HISTORIC AND DESIGN REVIEW COMMISSION

HDRC CASE NO: 2019-306
ADDRESS: 214 NELSON AVE
LEGAL DESCRIPTION: NCB 6397 BLK 2 LOT 14
ZONING: RM-4,H
CITY COUNCIL DIST.: 2
DISTRICT: Knob Hill Historic District
APPLICANT: Philip & Sheila Levin
OWNER: Philip & Sheila Levin
TYPE OF WORK: Front porch
APPLICATION RECEIVED: May 09, 2019
60-DAY REVIEW: July 08, 2019
CASE MANAGER: Adam Rajper

The applicant is requesting a Certificate of Appropriateness for approval to construct a new front porch on the existing structure.

— NORTH ELEVATION —

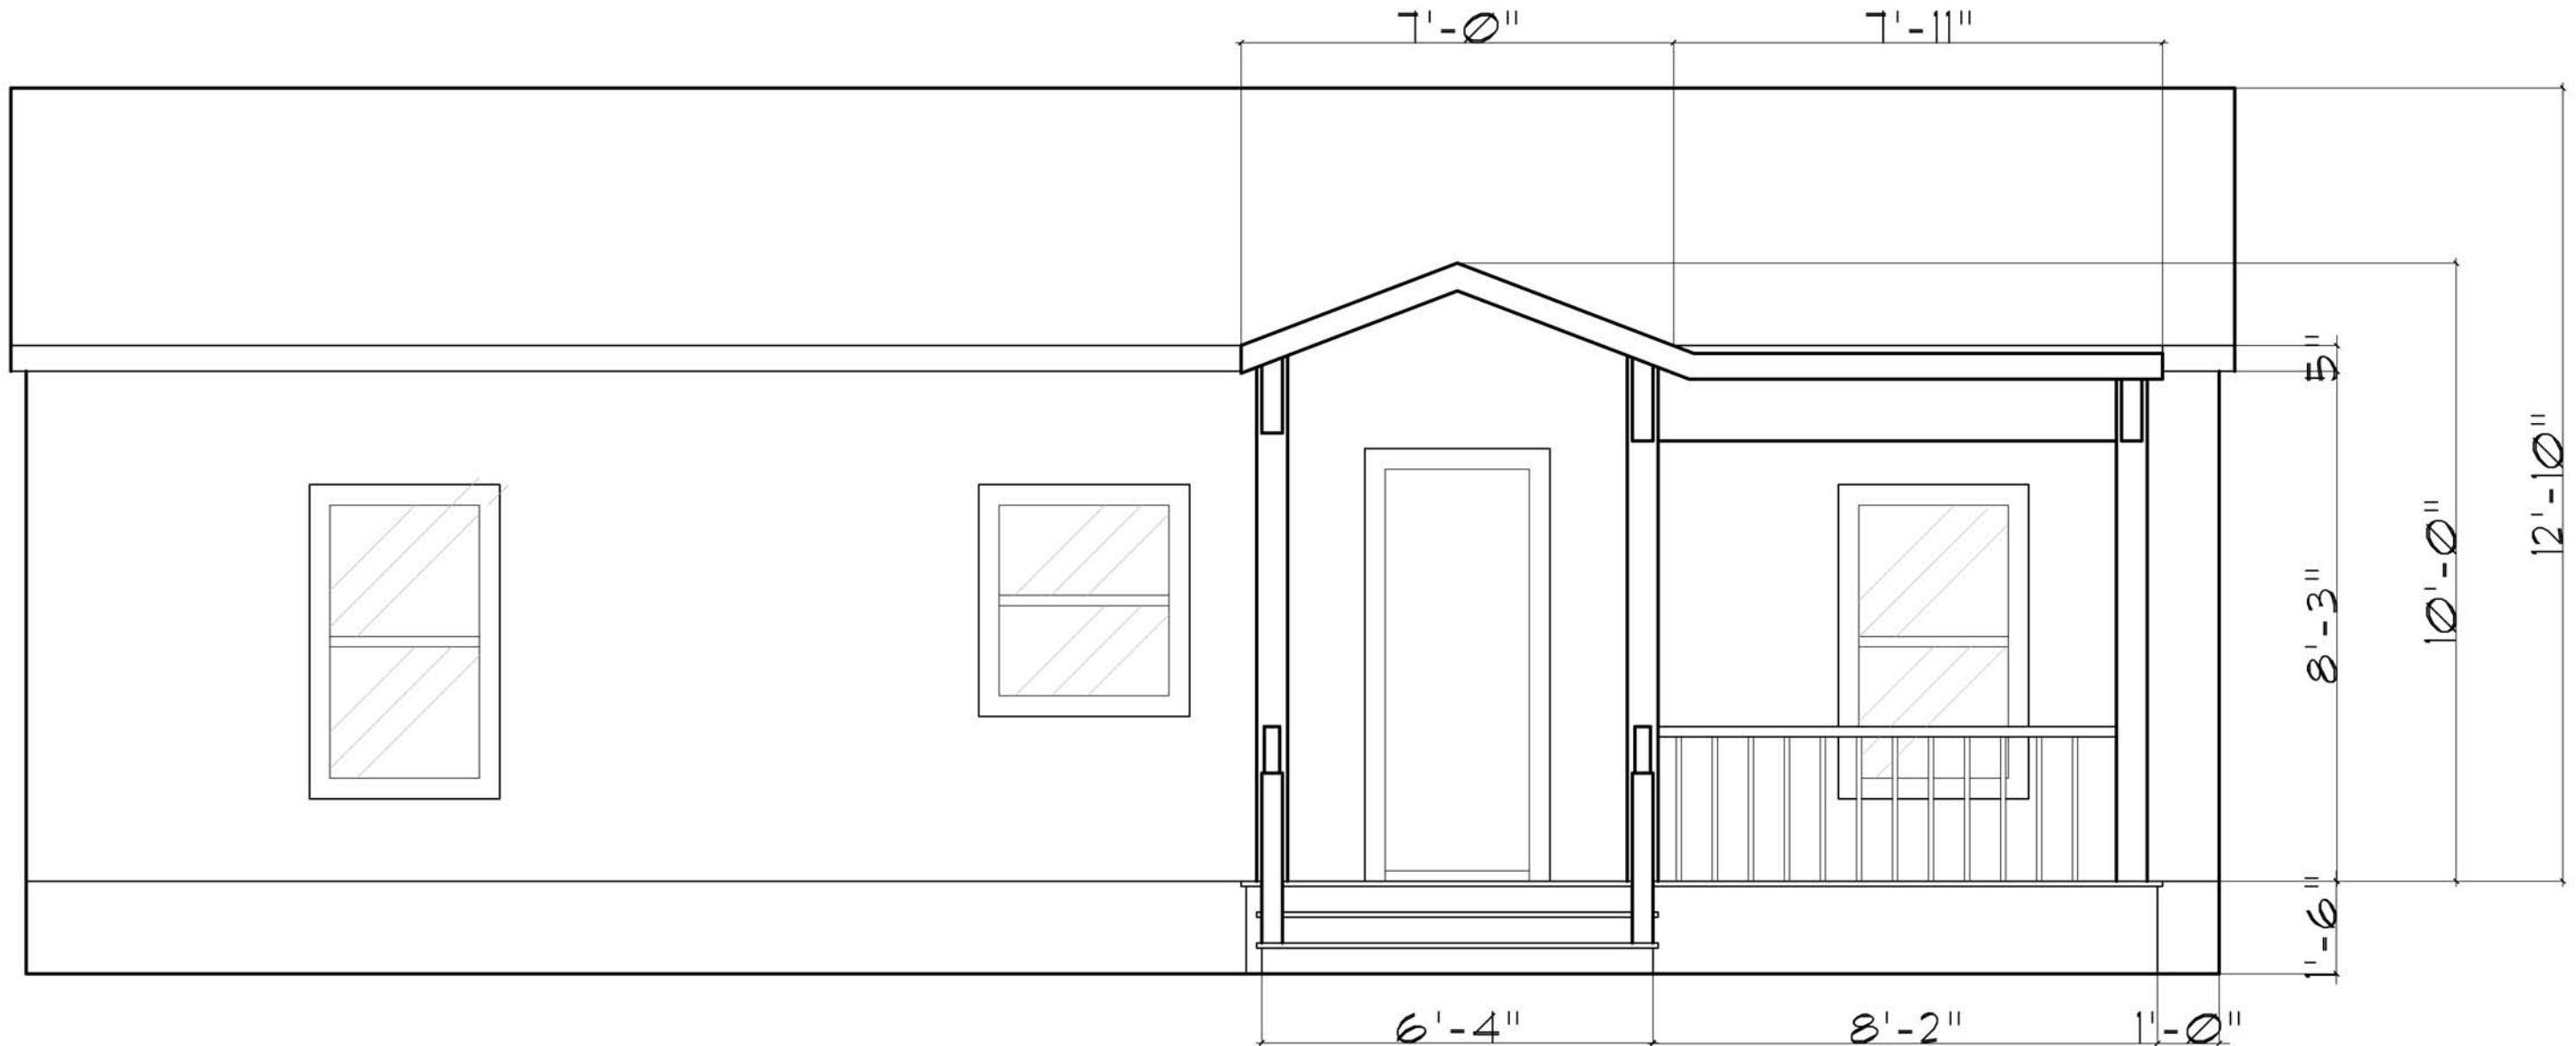
- b. FRONT PORCH: LOCATION – The applicant has proposed to construct a new front porch at the northwest corner of the existing structure. According to Guideline 7.A.i, new porches should not be added where not historically present. Sanborn maps indicate that the structure did not originally feature a front porch. However, staff finds that the proposed front porch is appropriate for the Minimal Traditional style of the home and does not conceal any of its character-defining features. Moreover, the porch will maintain a one foot recessed area at the northeast corner to provide a clear visual distinction between the old and new. Staff finds the proposal consistent with the Guidelines.

- c. FRONT PORCH: DESIGN – The applicant has proposed a front porch at the northwest corner of the existing structure. The proposed porch will feature a raised wood deck, front steps flanked by simple railings, a simple wrap-around balustrade, three wood posts, and a combination front-facing gable and shed roof. The existing front-facing gable of the home will be extended forward to achieve the gabled portion of the new porch's roof. The new porch roof will feature two roof materials; the gabled portion will be covered with composition shingles to match the existing material of the home's roof, while the shed roof portion will be covered by a membrane. According to the Historic Design Guidelines, new front porch elements should be simple as to not distract from the historic character of the building. Details should not convey a false sense of historic appearance. The proposed design responds to the existing geometries of the home without falsifying a sense of history. The configuration is also simple in design and will feature materials that are appropriate for the Minimal Traditional style of the home. Staff finds the proposal consistent with the Guidelines.

- d. FRONT PORCH: MATERIALS – The applicant has indicated that the new porch roof will feature two roof materials; the gabled portion will be covered with composition shingles to match the existing material of the home's roof, while the shed roof portion will be covered by a membrane. However, the applicant has not specified materials for skirting, decking, front steps, railings, and posts. Staff finds that the applicant should submit materials specifications for these items to staff for review and approval prior to receiving a Certificate of Appropriateness.

Staff recommends approval of the new front porch based on findings a through d with the following stipulation:

- i. That the applicant submit materials specifications for skirting, decking, front steps, railings, and posts to staff for review and approval prior to receiving a Certificate of Appropriateness.
